The manuscript presents an interesting study of CH₄ emissions from coal mines, but it is not well written in parts and many small sections need to be corrected / clarified (see attached PDF). For example, it is not clear what is meant by effective emission height and why it is different between the 2 flights when the emission point source (the stack) remains at the same height. There is very little discussion of the wider applicability of the technique. The abstract implies that it can be used to calculate emissions from coal mines, but the results section seems to suggest that it works only for single point sources, such as a vent or shaft, and that there would be big error bars on q if the emission was not from a point source. This needs to be clarified in the discussion. There should be some recommendation as to how many flights would be required to minimise the errors on the model results.

Dear Reviewer, thank you very much for all your comments on this manuscript, which are extremely helpful to improve the expression of our manuscript. We have revised the full text of the right based on the comments you marked in our manuscript PDF. And we make response to each comment one by

Fig.9. Measured gases concentration in downwind direction by Ground-based sensors, include in-situ network and vehicle-based sample system.

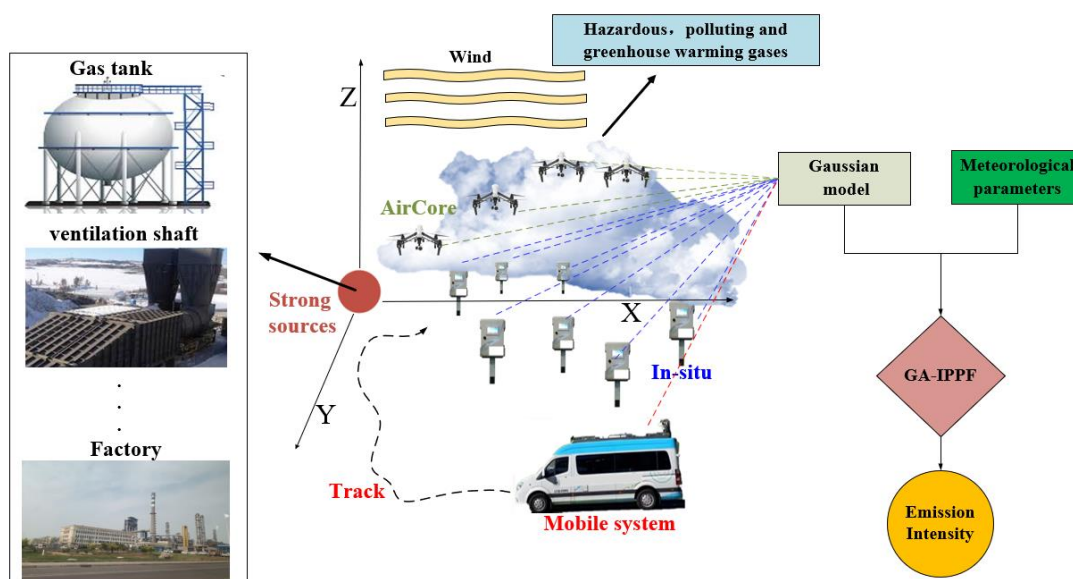
3. In section of Introduction, “Most ground-based sensors have the advantage to sample the concentration around the source continuously,” I presume you mean fixed location. This is also dependent on wind direction, so the emission will not be sampled all of the time, unless monitoring is inside of the source.

Thank you for this helpful suggestion, we are sorry for this incorrectly sentence. We strongly agree with you that ground-based equipment, such as vehicle-based monitoring system, and in-situ networking systems, need to collect data in downwind direction from emission source to be able to quantify the emission sources based on GA-IPPF. As shown in Fig 9.

“When ground-based sensors fixed in appropriate position, they have the advantage that sampling gas concentration in downwind direction form the source continuously”

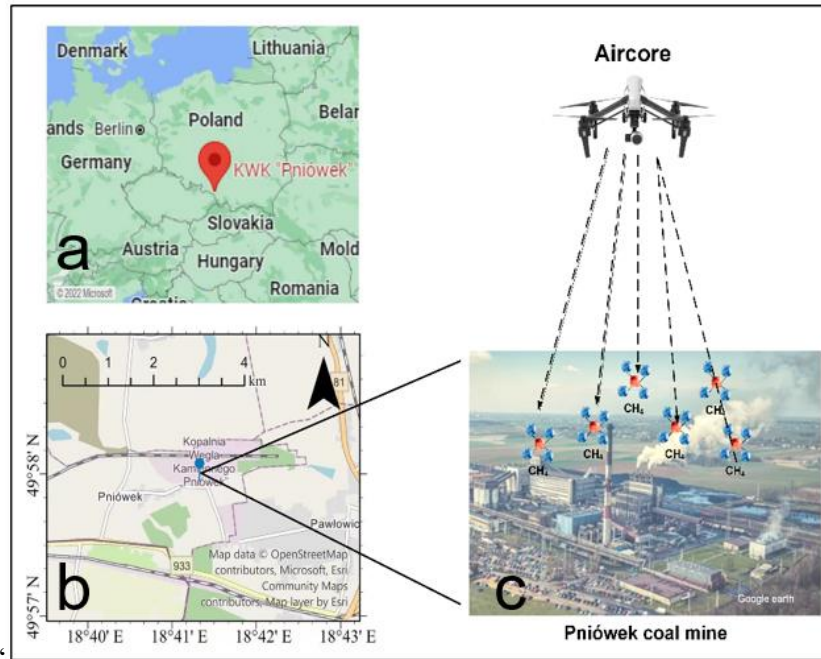
9. Fig2. Caption needs more explanation. What actually is the zoomed map showing? Where is the mine? Is pink the mine buidlings? is it deep mine with shaft or open pit?

Thank you for this suggestion, we are sorry for our careless to not indicate the detailed instruction of each map, and we added the information in our latest manuscript as follows:

“**Fig.2.** Pniówek coal mine; a. red mark represent the location of Pniówek coal mine in Poland; b. the surrounding circumstance of Pniówek coal mine, blue mark represent Pniówek coal mine; c. detailed layout of Pniówek coal mine, deep mine with shaft”

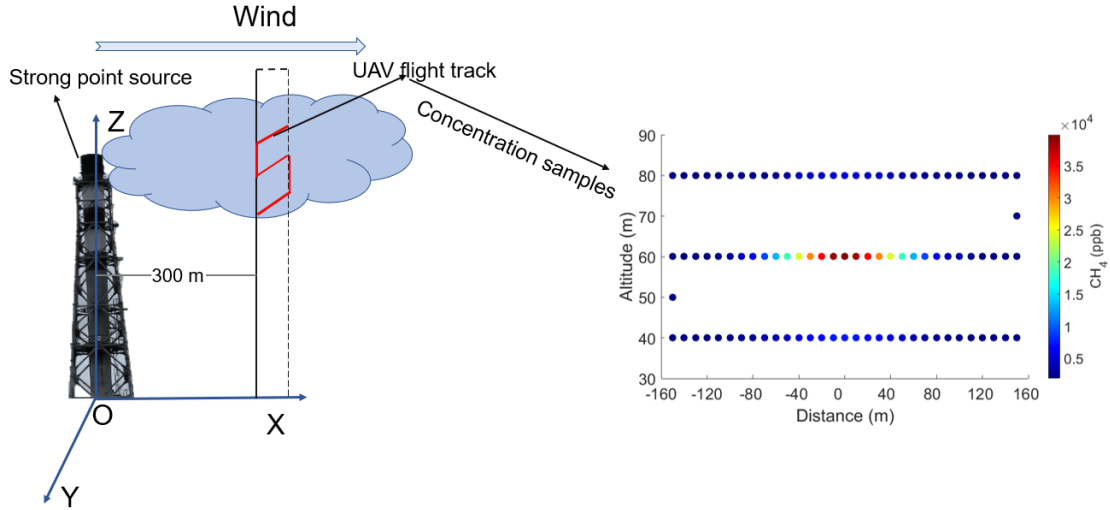
11. As for fig 3. Showing simulated data without showing any real 3-D data from the AirCore. What does this look like? What are you trying to simulated?

Dear reviewer, thank you for this suggestion, this suggestion is very helpful and we have revised this Fig in our latest submission as follows:

Then, the simulated flight track of UAV was conducted in crossing section (300 m to strong source), in Fig 7. To make this Fig 7 easier to understand, we have revised the illustrations for this Fig 7 as followed,

Fig. 7. Rectangle represents crossing section perpendicular to wind direction, 300 m to point source; Red line represents simulated flight track of UAV-based Aircore system; colored points represent the CH₄ concentration samples in OSSEs, totally 99.

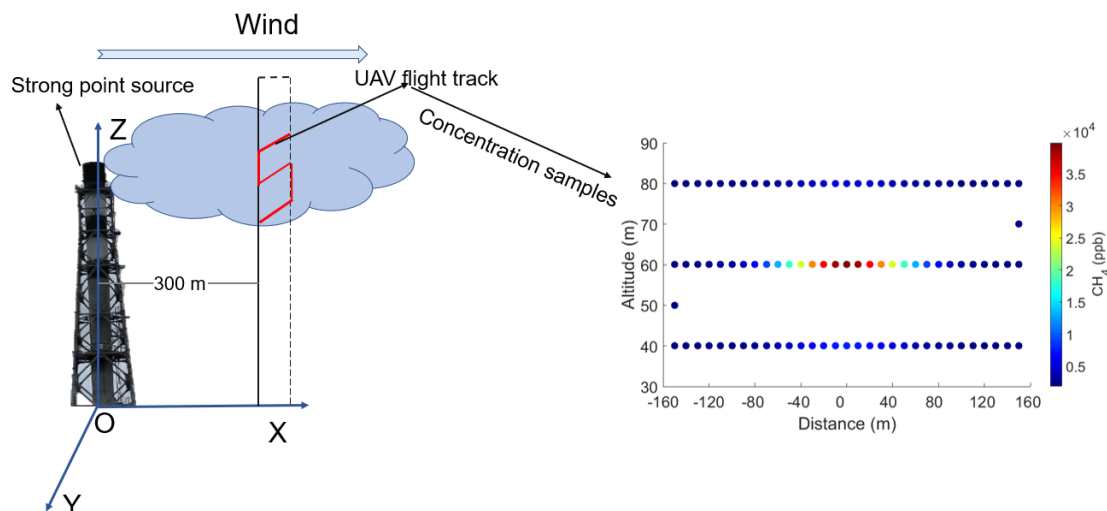
17. In line 228, “The AirCore system could acquire more than 70 CH_4 samples in actual feasible measurements” . Not clear what this means. Number of air Core samples that can be collected and analysed within a given time period within the same source emission plume.

Then, the simulated flight track of UAV was conducted in crossing section (300 m to strong source), in Fig 7. The spatial resolution of the supposed samples is 10 m, and 99 samples were selected from the simulated dispersion to represent the data acquired by the UAV-based AirCore.

We want to model the colored point to represent the concentration samples in actual Flight. Aircore system is actual sampling continually during the Flight, the spatial resolution is 10 m in this section, which is regarded as the integral period of each value of CH₄ concentration in different locations.

“UAV-based AirCore system could acquire more than 99 CH₄ samples (with accuracy better than 99.5 %) in single Flight.”
